TRANS/WP.29/708
9 May 2000

DRAFT SUPPLEMENT 5 TO THE 09 SERIES OF AMENDMENTS TO REGULATION No. 13

(Braking)

"3. Example of a simulator for electric control lines

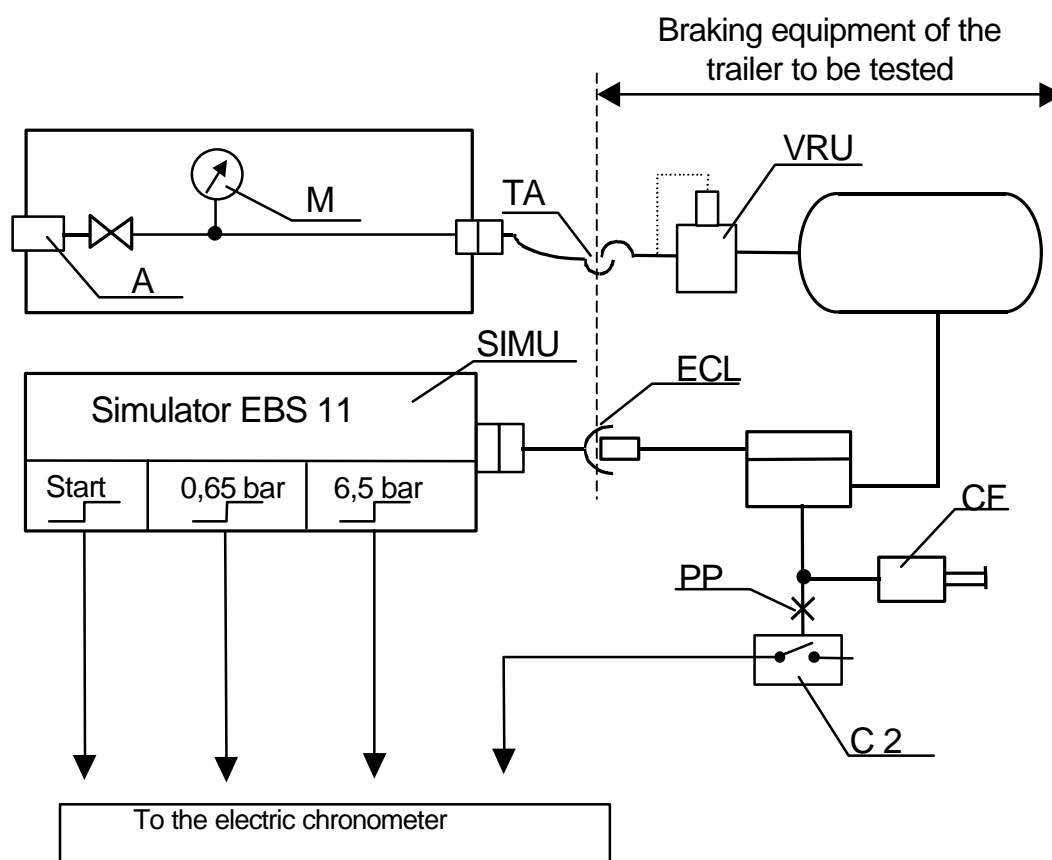
Annex 6, appendix, insert a new figure 3., to read:

ECL = electric control line corresponding to ISO 7638

SIMU = simulator of Byte 3,4 of EBS 11 according to ISO 11992 with output signals at start, 0.65 bar and 6.5 bar."
